S E R V I C E**N O T E**

Supersedes:
E8362A-01A

E8362A PNA Series RF Network Analyzers

Serial Numbers: 00000000 thru 46999999

Figure 1

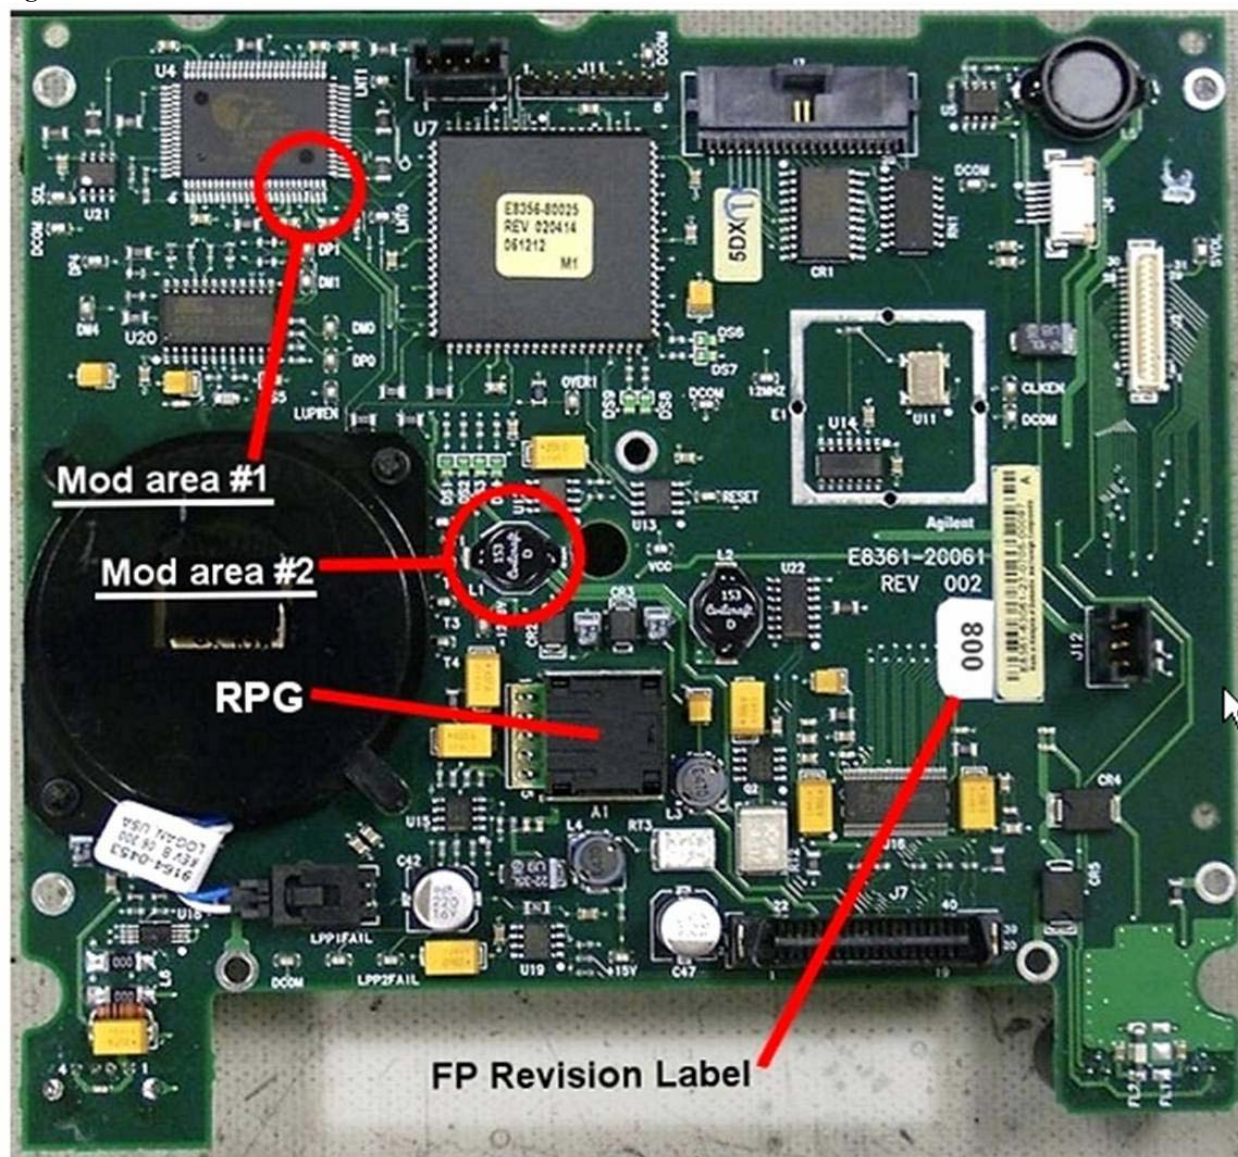
Refer to Figure 1 for the two modification areas to be addressed. Note that while this picture happens to show the FPI board completely removed from the front frame assembly, this is not necessary to perform the required modifications.

- Modification #1 consists of shorting two pins of U4 together with a small amount of solder.
- Modification #2 consist of removing L1.

Unsolder and completely remove the black surface mount inductor L1 from the front panel assembly board. This is no longer needed and can be discarded.

Figure 2

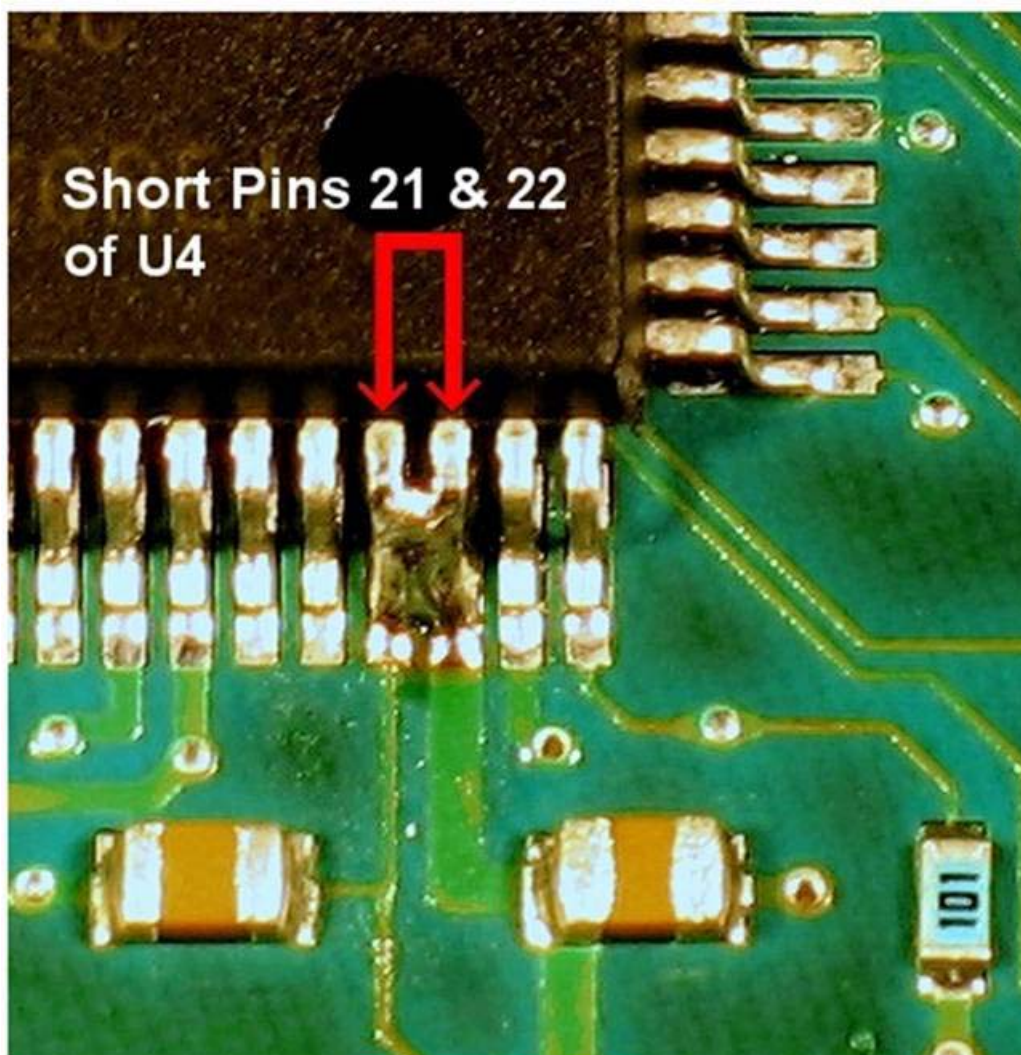
Carefully solder pins 21 and 22 together on U4. Refer to Figure 2 for the exact location. Use care so that no other pins are shorted. Use of a very fine tip soldering iron is recommended and a large work-task magnifying glass is very helpful.
